\* User name: SHAW (11) Queue: UIDEK/UNIX\_UIMKGT  
 \* File name: Server: CLFPCD010  
 \* Directory:  
 \* Description: NORDIC40.  
 \* December 21, 1998 5:46pm

DELTA LIST OVER PREVIOUS PINOUT RELEASED ON :

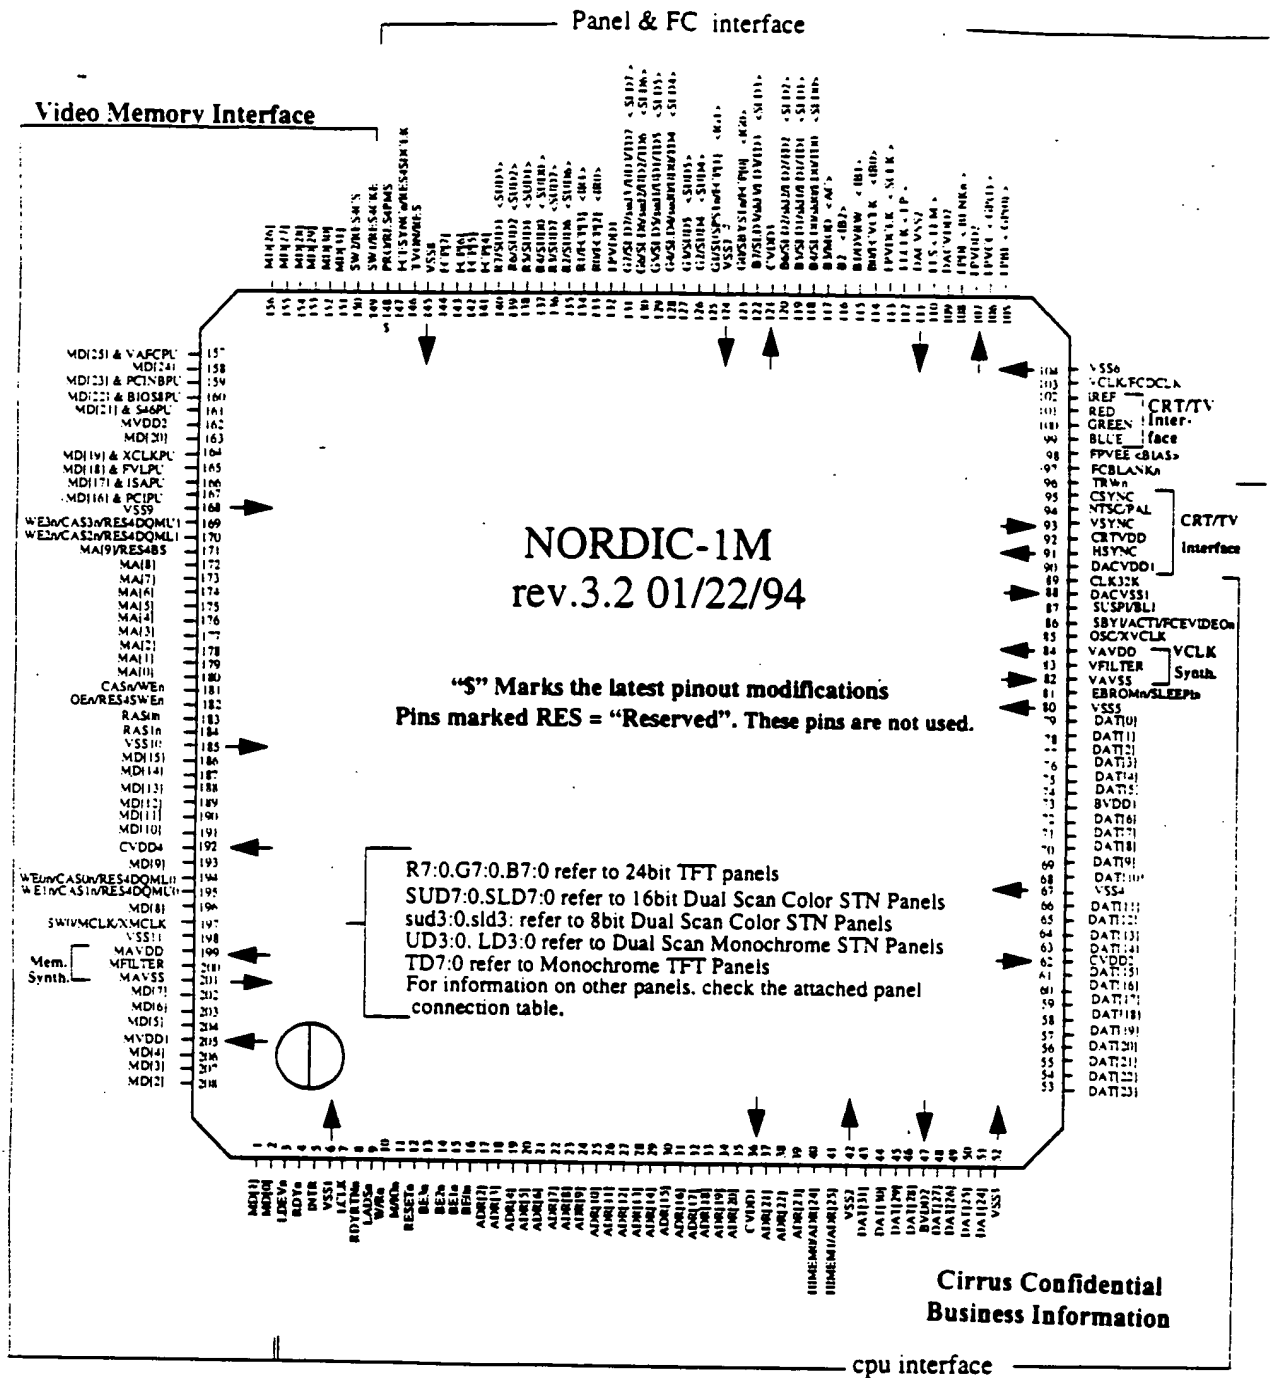
- no POUT on SW2/POUT
- XVCLK moved from SW1/VCLK/XVCLK to OSC/XVCLK. This way SW1/VCLK/XVCLK became SW1/VCLK.

- All panel pins whose names were not starting with the color panel name were changed such that the names start now with the color panel pin (R7, G7, B7 and so on). So it was only a pin name change.

1. Took-out Whisper Support Pins: WWRn, WRdn, WAD[3:0], FPCn.
2. Reduced the number of CPU Address Pins: ADR[24:27] went-away. Use HIMEM to place the chip outside 16MB of memory for linear addressing.

3. Killed CRTVDD and placed CRT Interface on Host Bus VDD.
4. Introduced VAFC pins in a unique pinout configuration in both VESA VL and PCI.  
Added VAFCPU a pull-up to enable VAFC (VESA Advanced Feature Connector).  
ADR[27:24] become VAFC pins, and R[7:4], G[7:6], CLK32K, SUSPI/BLI, SBYI/ACTI get a configuration for VAFC -> total 14 pins.  
SW0/VCLK will be used as VAFC DCLK, losing SW0 pin as panel type when VAFCPU is used.  
In PCI bus, no ADR pin will be shared with VAFC.  
ASW0PU will be added on MD pins to replace SW0 pin when VAFC is enabled by VAFCPU. SW0PU will read-back in the same register bit as SW0, so the BIOS will not feel any modification in the reporting scheme.  
The chip will draw more power in suspend with VAFC.

5. Moved SW2, SW1/MCLK/XMCLK, the two RESERVED pins and TRWn on MVDD to prepare for SDRAM pin compatible option in the next Nordic that supports SDRAMs. It looks that we need only 3 more memory pins to support SDRAM-s so TRWn will not be used. It was moved so it is on the right VDD bus if needed.

6. Moved CVDD3, VSS3, VCLK Synth, H/VSYNC, EROMn, SW0 per Thomas Hung's request to fit the floor plan.

1. Added AUXS1 on D/Cn as an option to be used with CS4231S as CS.
2. Added AUXS2 on EROMn/VADRn as an option to be used for Sound Synthesizer Chip Select.
3. Rearranged 5428 FC pins due to a previous error : R5 and R4 should not be used with FC.
  - FCP[1:0] are shared with G7 and G6.
  - SW2 and the two pins reserved for SDRAM were moved in between Video Memory pins and Panel pins and one of them is used as FCESYNcn.
  - OVRW is shared with CLK32K, FCBLANKn is shared with SUSPI and FCEVIDEn is on SBYI.
4. Renamed the External Clock PU XCLKPU instead of XMCPU.

1. Moved some external pull-ups.
2. Added alternate pin functions on panel pins as well as actual schematic name for engineering
- 10/27/93
1. Added TV-OUT (called also NTSC-OUT) pins on the panel pins

1. Added TVG on EBROMn/AUXS2 and took out VADR as an option on this pin.
2. Put back FCESYNcn on RES4SDCLK as an option (deleted by mistake).

1. Reset became RESETn, active L to correspond with the defined reset signal for VESA VL and PCI.
2. TFT Panels Data Pins R7:R0, G7:G0, B7:B0 changed and all pins got rotated to get them ordered from right to left. Due to this change now Ri=TVRi, Gi=TVGi and Bi=TVBi.

1. Update Panel Data Pins based on Robin's Table.
2. Move MOD pin on a Panel Data Pin used in 18bit TFT.
3. Move OVRW on a 24bit Panel Data Pin.
4. Removed pin configuration for TV-OUT support with digital encoders. All pins marked TV... were removed. As a result, some pins like LLCLK, LFS, FPDE, FPVDCLK have one function now.

5. Removed WavePort pins, including AUDVDD: total 7 pins freed.  
AUX2 and TVG muxed on EBROMn are no longer needed either.
6. Added one more CPU address pin: instead of HIMEM, Nordic has now HMEM0 and HMEM1, corresponding to CPU Address 24 and 25 or any other external decode of the high order CPU address bits. In the process of adding this pin, most CPU Interface pins on the right side were moved to the right by one pin.

7. Added CRTVDD supplying HSYNC, VSYNC, CSYNC, NTSC/PAL CRT and TV Interfaces output buffers.
8. EBROMn is shared with TVON, the power-on signal for AD720. So, in ISA bus with on chip BIOS support, AD720 power on cannot be directly controlled by Nordic.

9. Added pins for Analog TV Encoder support - AD720 and MC1377 :
  - a. CSYNC = Composite Sync signal
  - b. NTSC/PAL = 1 -> NTSC, 0-> PAL (for AD720, but it is TV Encoder Dependent)

- c. EBROMn/TVON (see #8).
10. ASW0PU "Alternate Switch 0 Pull-Up" pull-up on pin 155. MD[26] was removed, as SW0 is now not multiplexed.
11. De-multiplexed some of the pins previously multiplexed:

- a. Pin 168 TWRn/RES4PMS is now RES4PMS, a pin reserved for synchronous DRAM support.
  - b. SUSPI/BLI/FCBLANKn is now SUSPI/BLI, not affected by the Feature Connector Enable Configuration

- c. As a consequence of b, pin 97 is FCBLANKn (not muxed with anything).  
Please note that FCEVIDEn is still muxed with SBYI/ACTI as before, as Standby Input and Keyboard Activity are less important functions in a system.

- d. SW0 is no longer muxed on VCLK/FCCLK. So VLK/FCCLK is a pin but it moved to pin 103 in the PVDD area, to be consistent with FC power supply.
12. SW1, muxed on MCLK/XMCLK (pin197) became SW0. This is just a name change to have the switches placed in a more consistent manner.

13. SW1 is now muxed with a reserved pin: RES4CKE, pin 148, which before was totally reserved. The idea here is to go for pu/pd with SDRAM-s for SW2 and SW1, while keeping SW0 on MCLK even with SDRAM-s.
14. Pin 147 is Reserved. It is actually one of the WavePort pins, but placed in-between Memory and Panel VDD busses (on MVDD) for maximum flexibility. To achieve this, the pins on its right were moved to the right by one FPVDD <BIAS> moved down to pin 98 (it was 105).
15. TRWn is now by itself on pin 96, on FPVDD.
16. The names of all flat panel data pins reflect the panel type table attached to this document.

1. On EBROMn/TVON -> EBROMn/SLEEPIn with SLEEPIn an input which if L puts Nordic to sleep (as 3C3[0] and 46E8(3).
2. TVON is now on RES, but TVON/RES is pin 146 and FCESYNc/RES4SDCLK is pin 147.

1. Pin 148, RES4PMS which was a pin reserved for synchronous DRAM-s, got a function: it is now a programmable output PRO and it is on FPVDD instead of MVDD. The intention is to optionally use this pin to control a switch between 5V and 3.3V, in which case a H level of 5V is desirable. My primary choice for this function is actually NTSC/PAL pin which is on CRTVDD, but if the TV-OUT option is used in a system and a switch between 5 and 3.3V is provided, PRO may be used.
